APPLICATION FOR SUBMITTAL OF POST-APPROVAL DOCUMENT

APPLICATION FOR SUBMITTAL OF POST-APPROVAL DOCUMENT

5 GAS SERVICE TRENCH
NTS

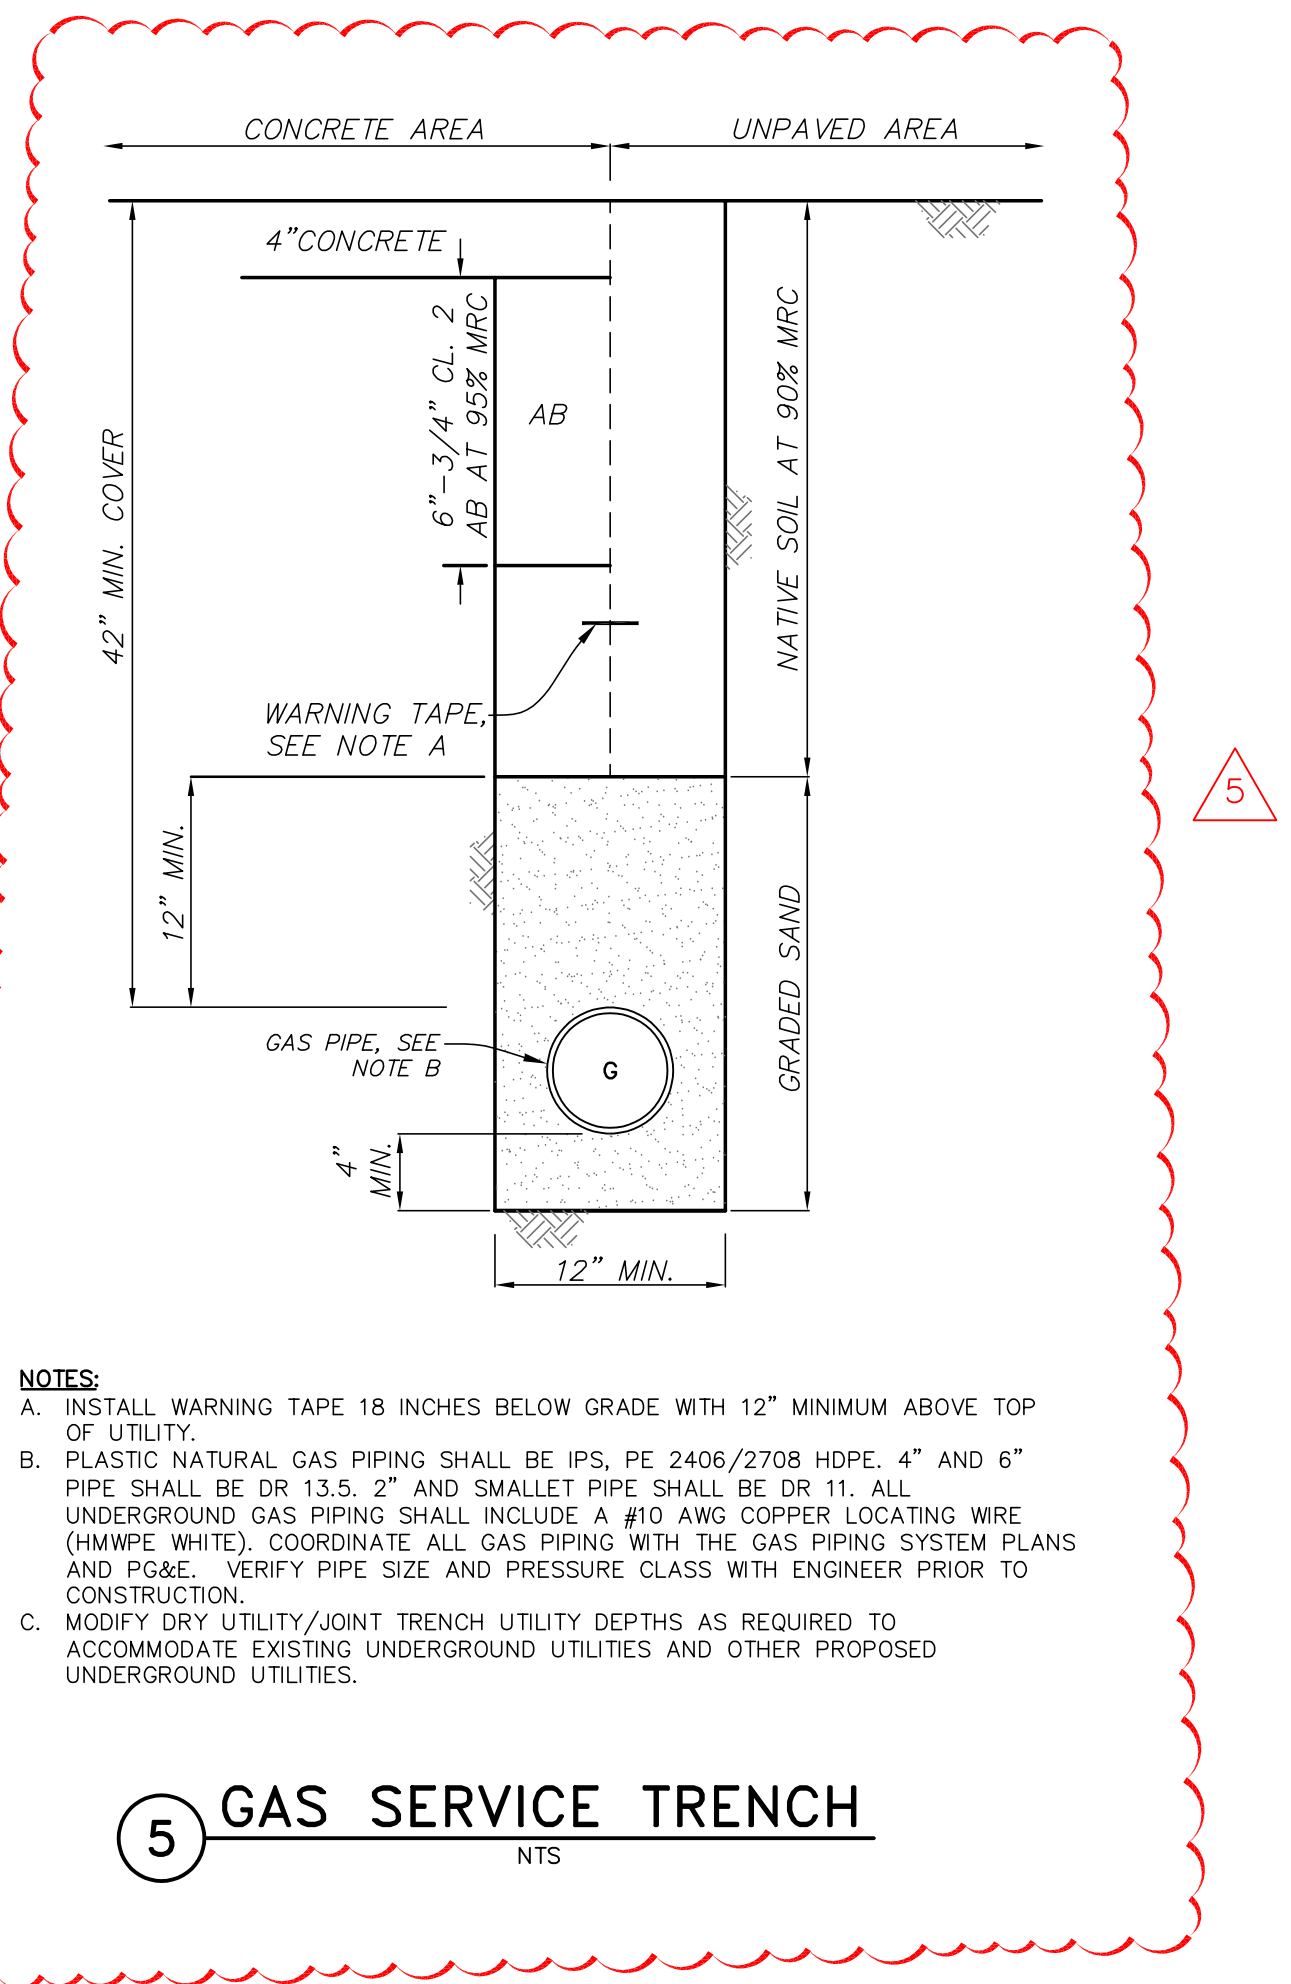
- e. **C302** – update grading points
- f. **C603** – added Gas Service Trench Detail
- g. **L1.0**
 - i. Lighting quantities in legend have been revised to accurately reflect current landscape plan.

drawing title:
LAYOUT PLAN
drawing no.:
L2.0
drawing of

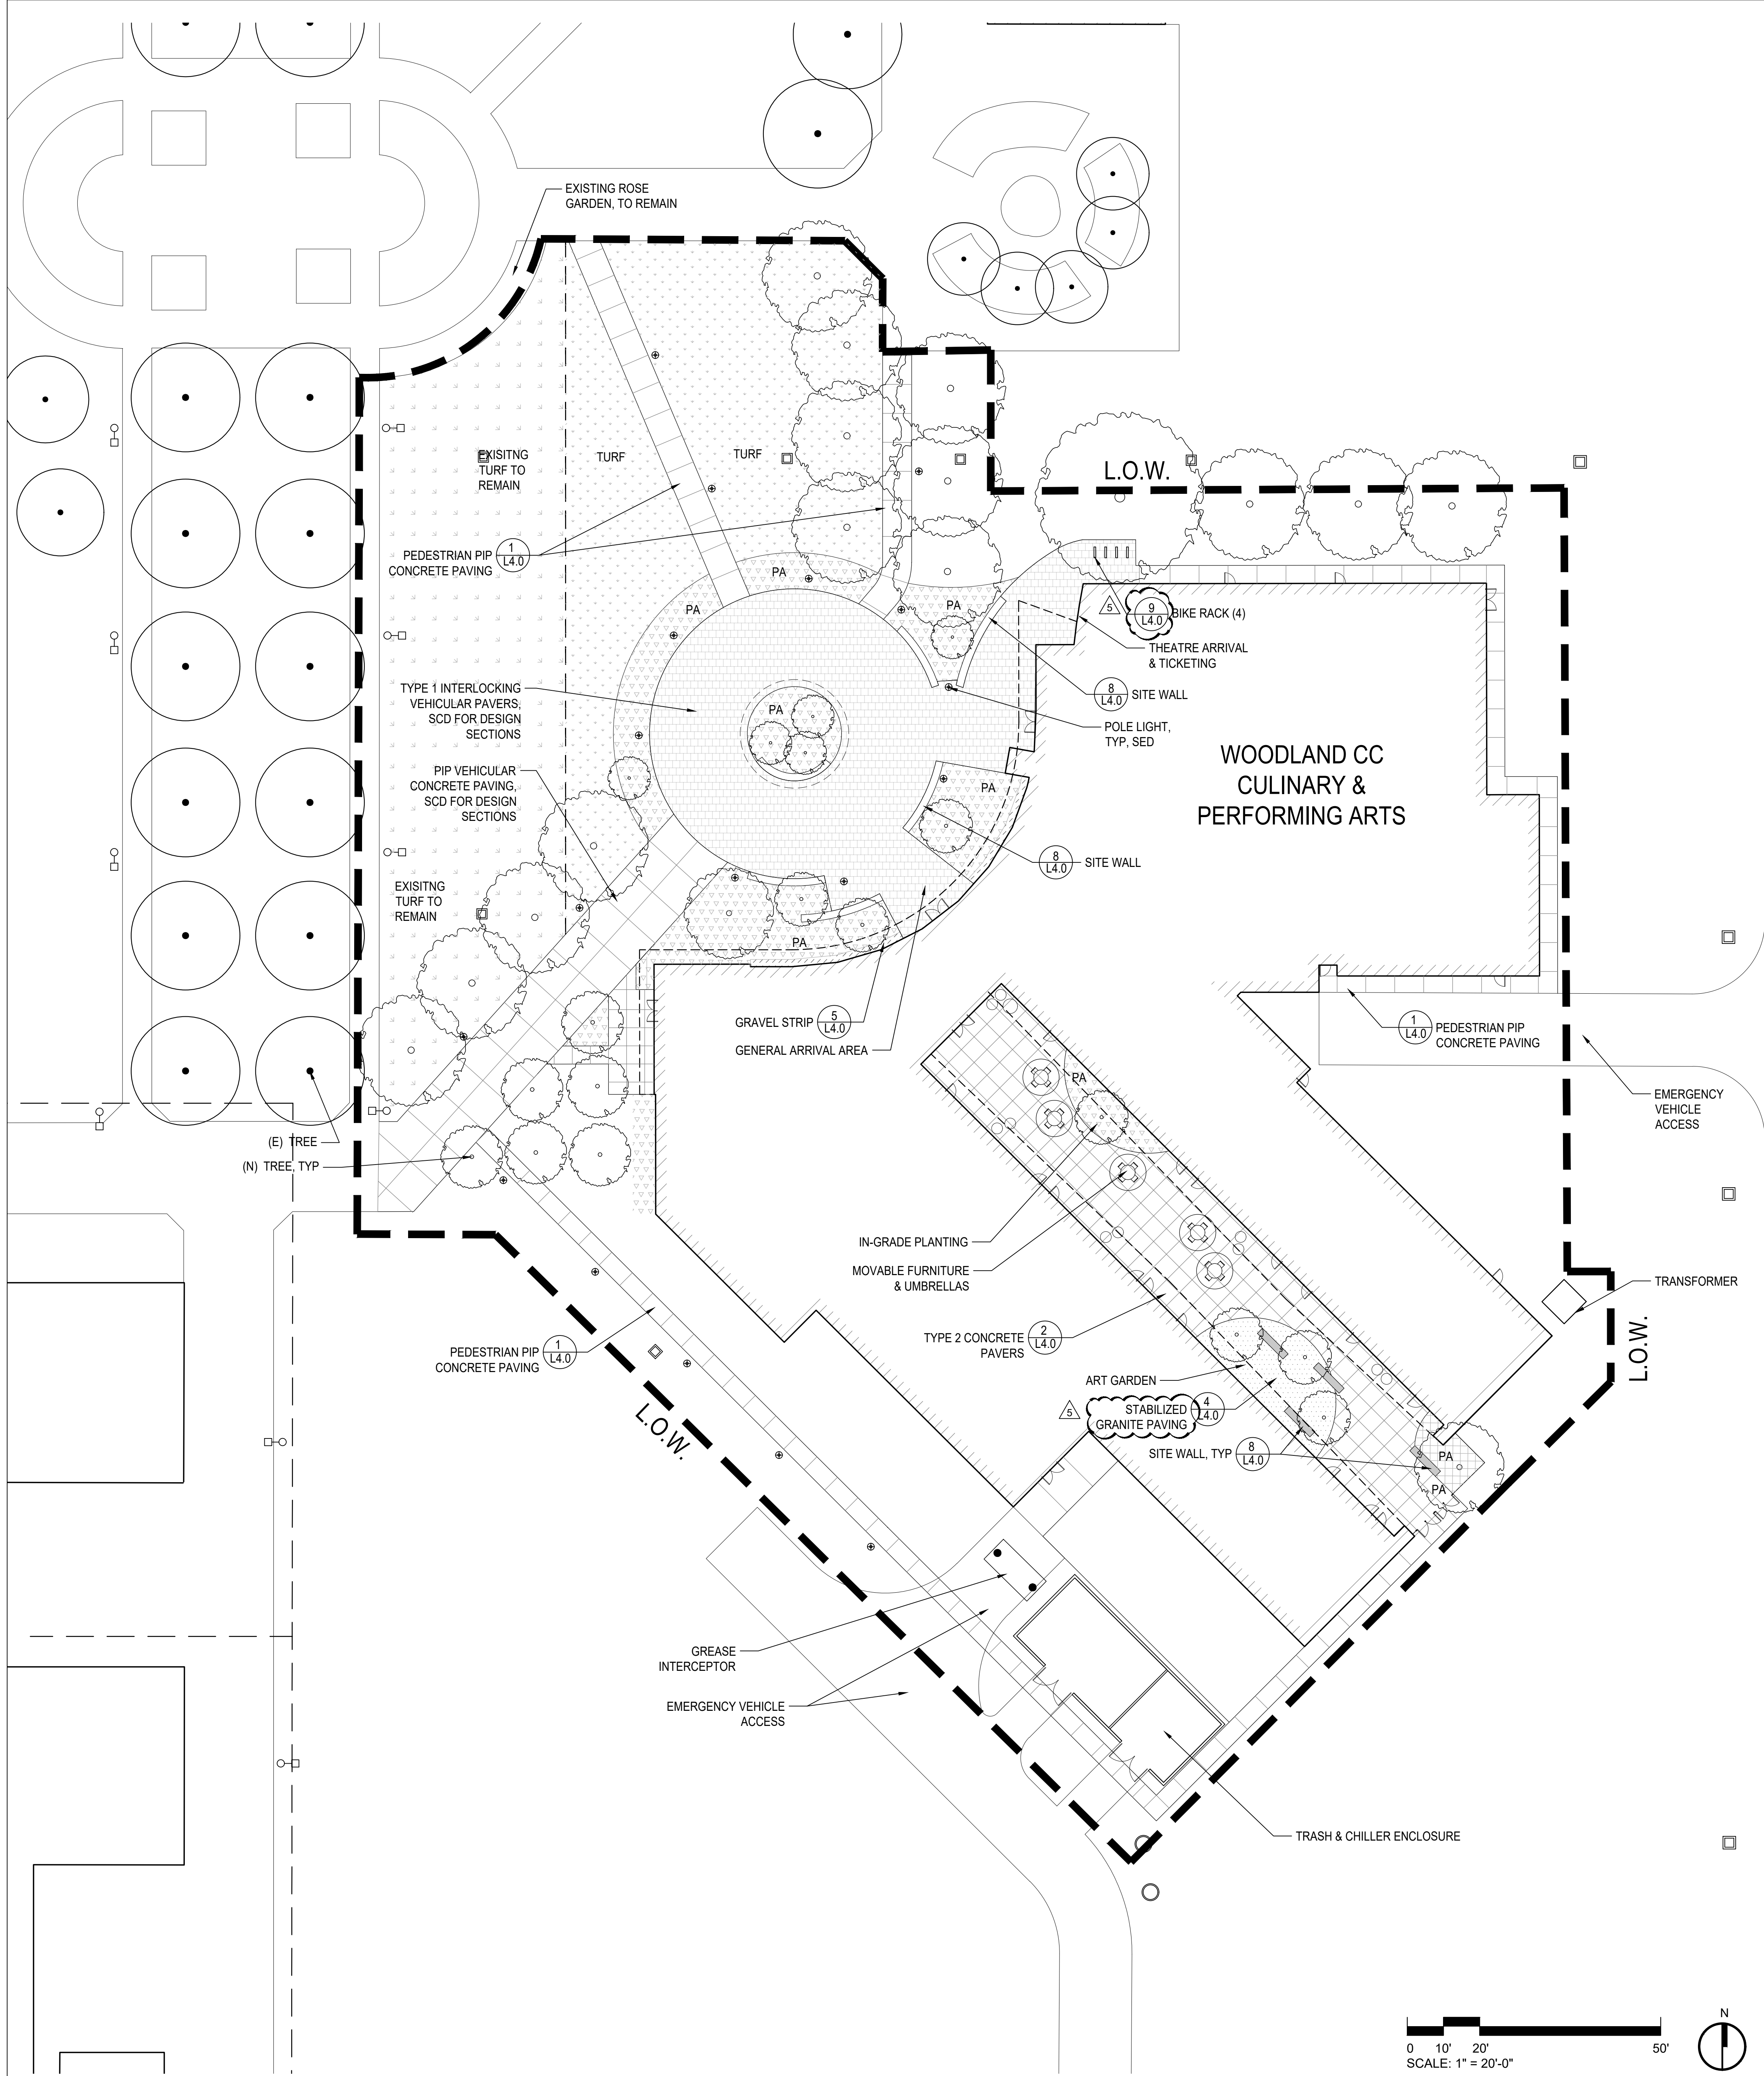
- h. **L2.0**
 - i. Lighting quantities in legend have been revised to accurately reflect current landscape plan.
- i. **L3.0**
 - i. Detail callout for 9/L4.0 Bike Rack added to plan.

4 STABILIZED GRANITE PAVING

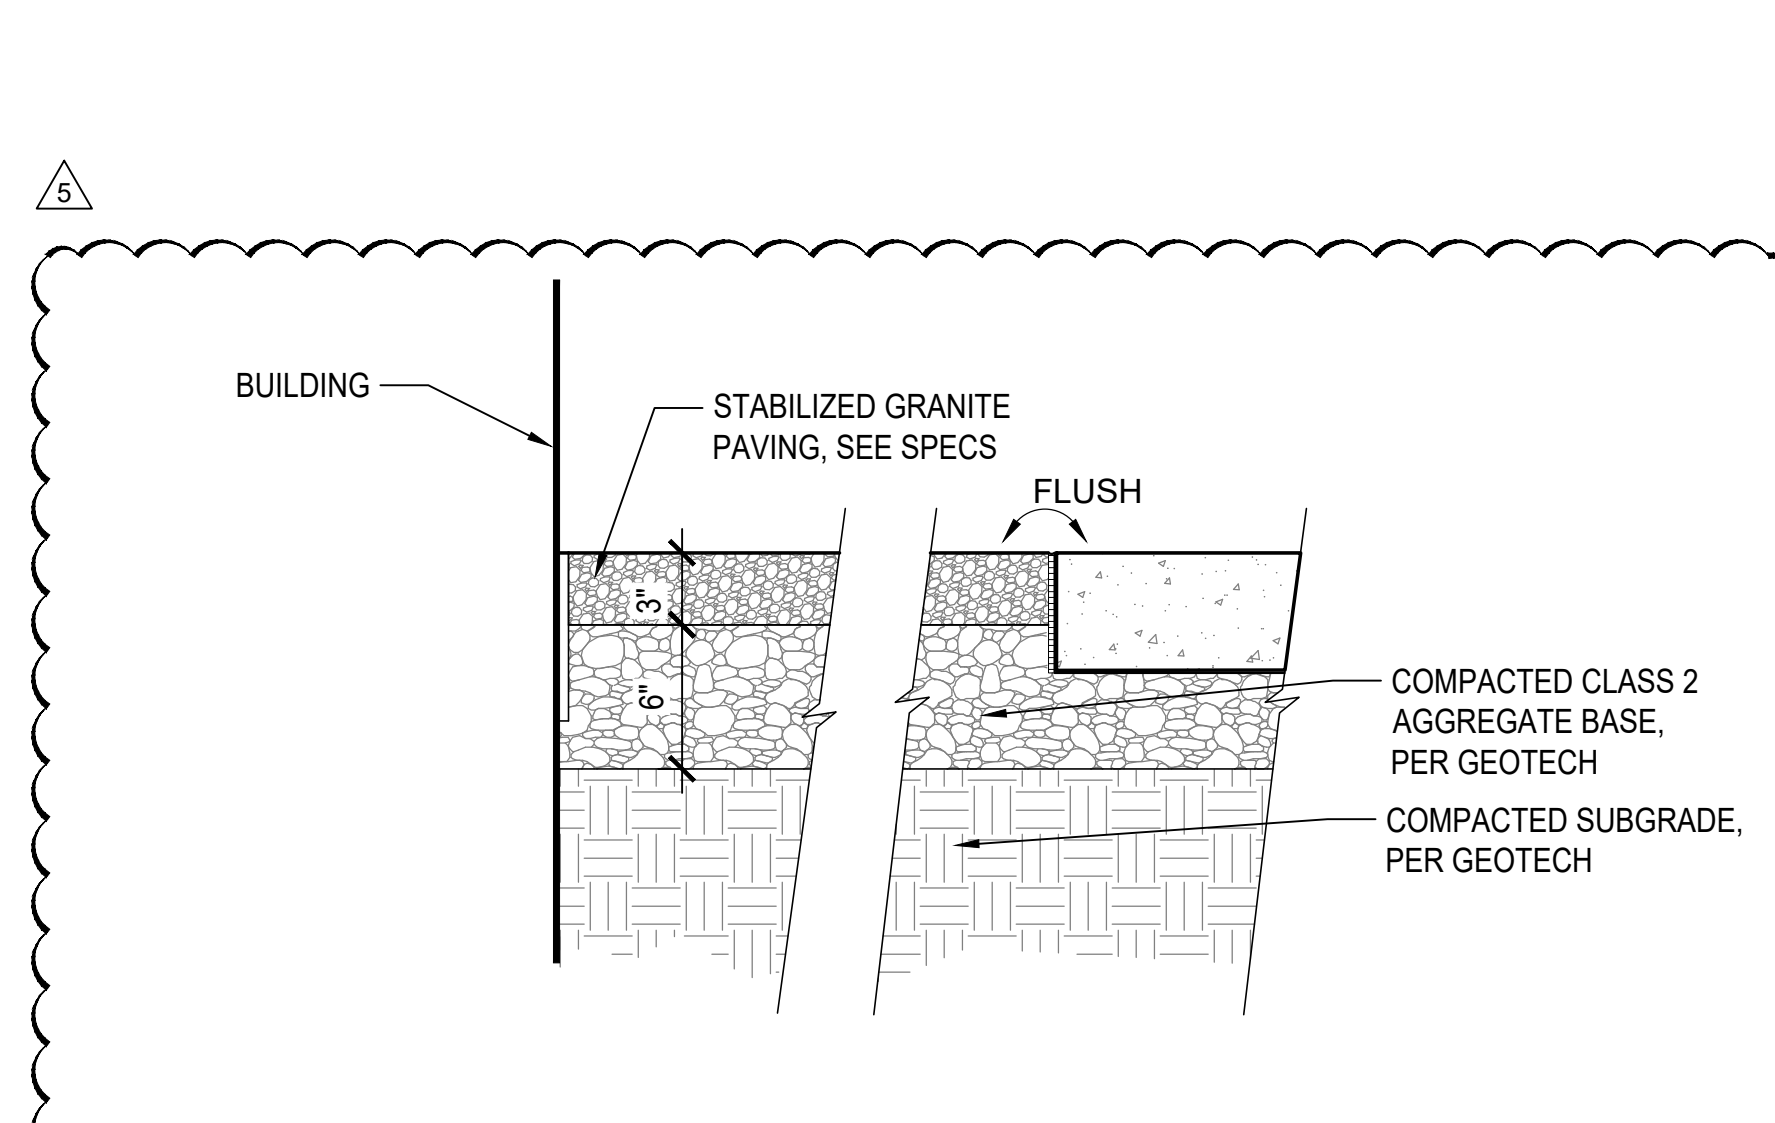
- ii. Detail 4/L4.0 has been renamed Stabilized Granite Paving and updated per specifications.
 - iii. Detail 5/L4.0 Gravel Strip has been revised. Gravel strip to be ¾”, Sonoma Gold gravel. Compacted aggregate has been revised to extend 6” beyond landscape edging.

5.L3.0 calls out a gravel surface as 3/4" Sonoma Gold color per 4/L4.0, this detail calls out "Gravel, See Specs". Is this material intended to be the specified Stabilized Granite Paving 32 15 40?	RHAA	The "Gravel Surfacing" indicated on Sheet L3.0 has been revised to "Stabilized Granite Paving". Please refer to detail 4/L4.0 Stabilized Granite Paving and specifications. The gravel shown in detail 5/L4.0 Gravel Strip should be 3/4" Sonoma Gold aggregate or approved equal
1/3/22	Lathrop
